# Southgate KXLY

## Recommendation Meeting

### Staff Report

March 13, 2017

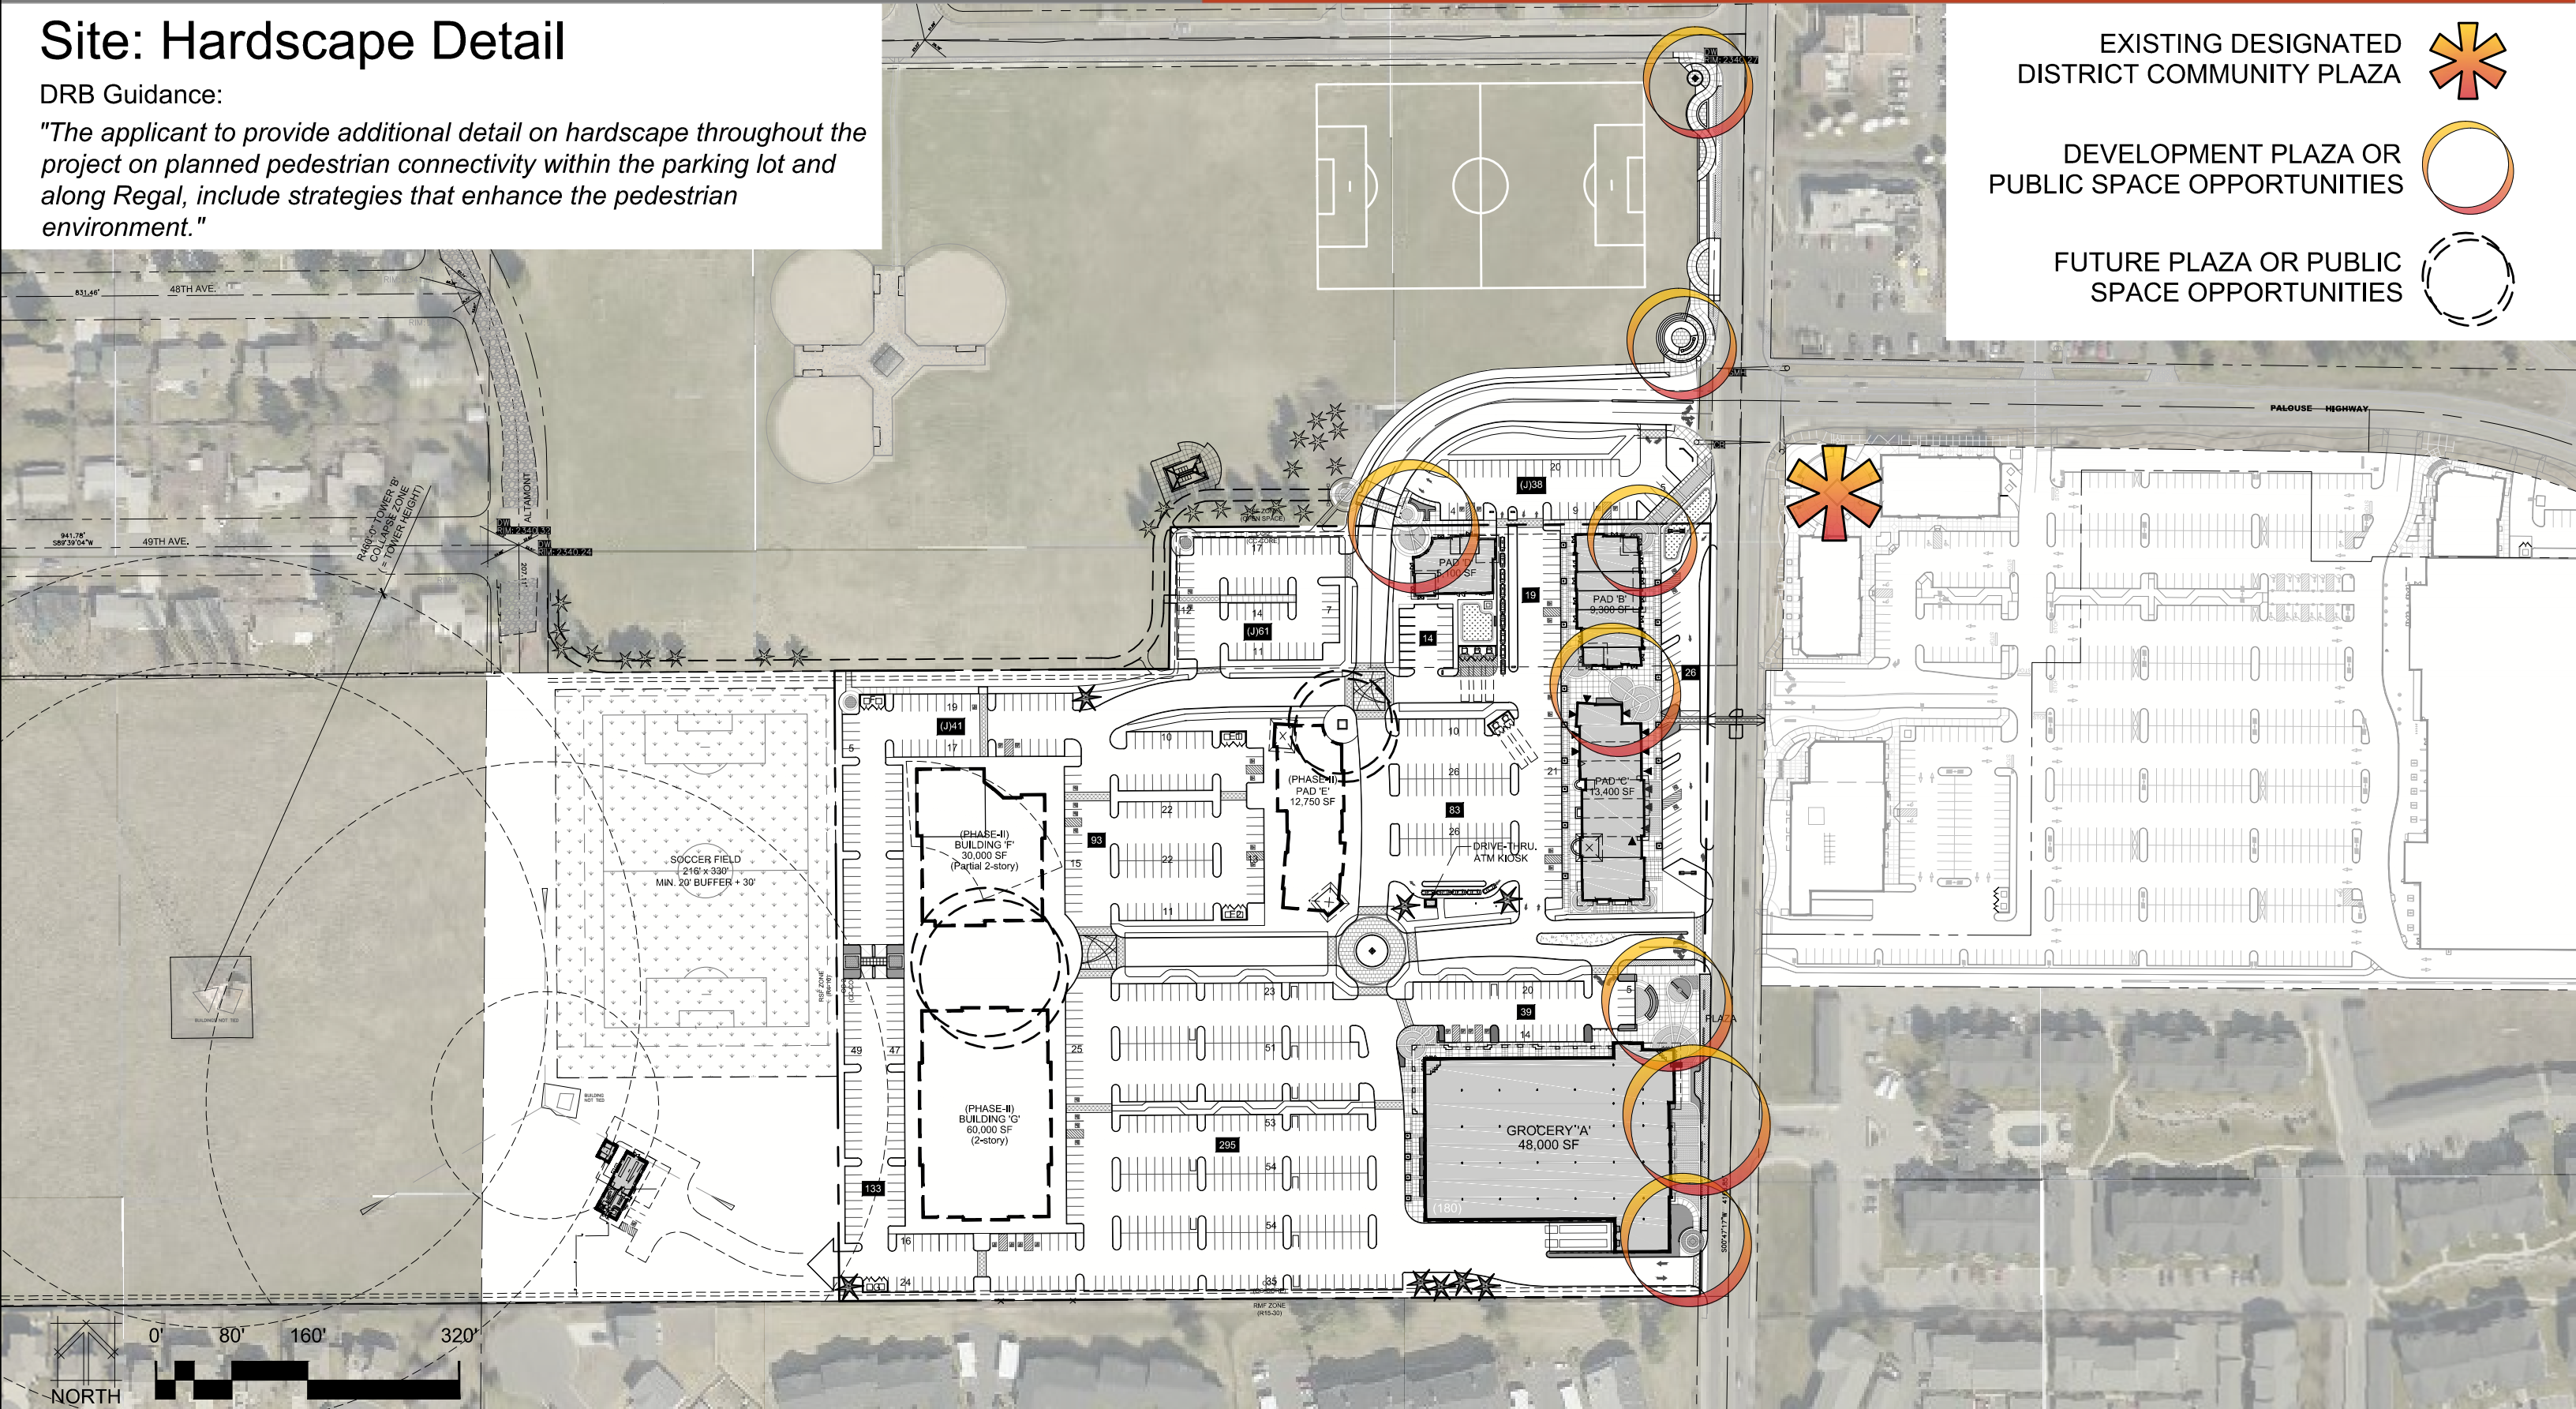
"The applicant to provide additional detail on hardscape throughout the project on planned pedestrian connectivity within the parking lot and along Regal, include strategies that enhance the pedestrian environment."

## 1 Retail-A South Elevation (Presented at Collaborative Workshop)

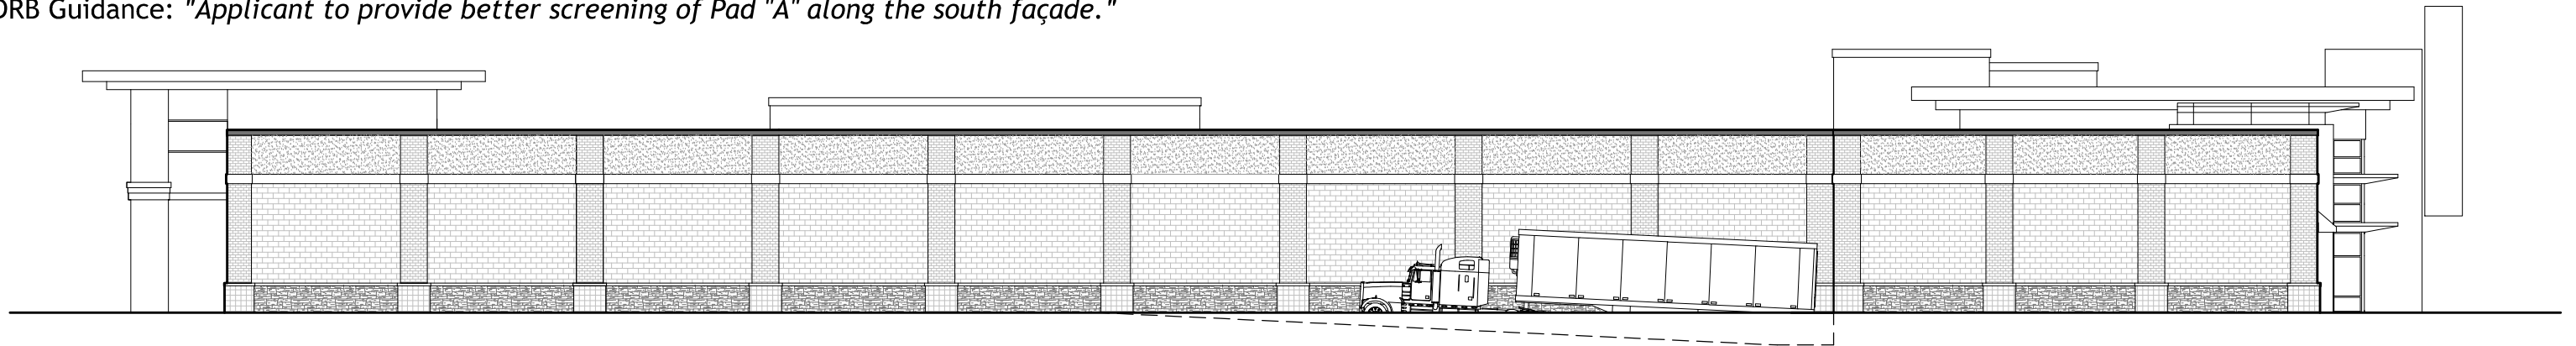
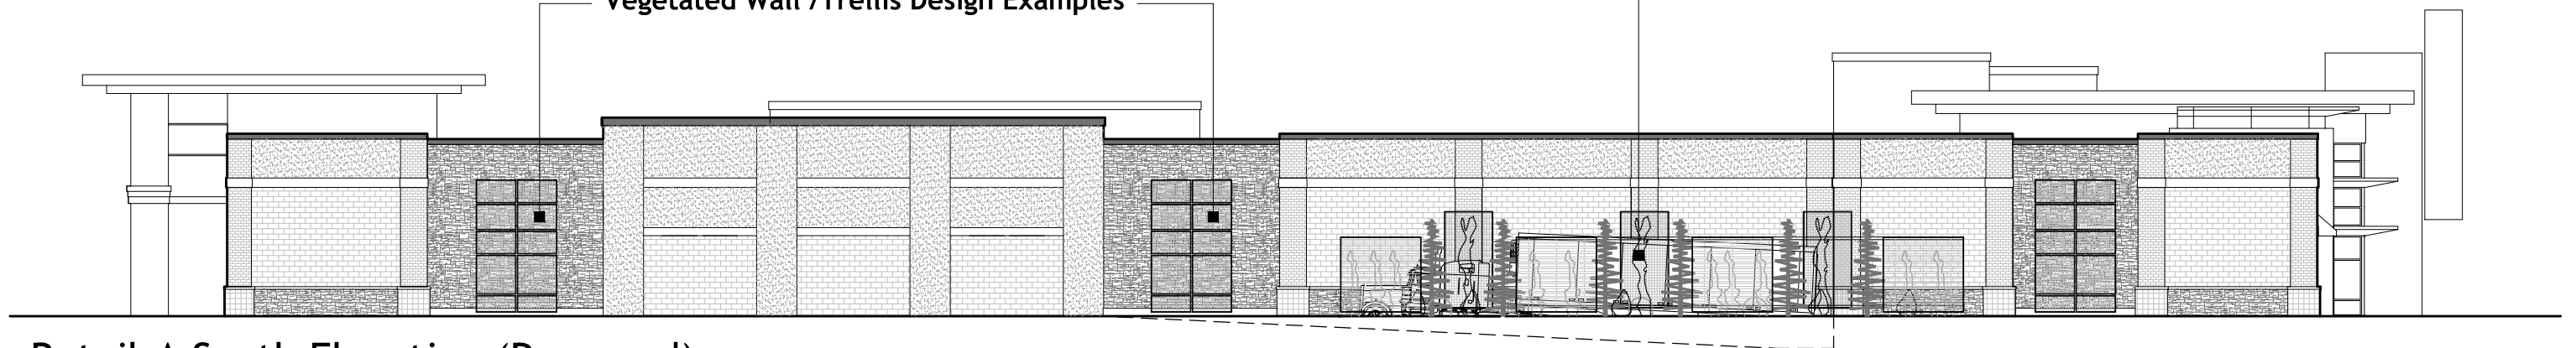
DRB Guidance: "Applicant to provide better screening of Pad "A" along the south façade."

In addition to incorporating Ponderosa Pine into select areas of the landscape buffer screen, the south facade' has been enhance with vegetative screen walls located between the Retail-A service area and the property line. Parapet articulation and changes in materials and textures are also used to reduce mass and visual impact.
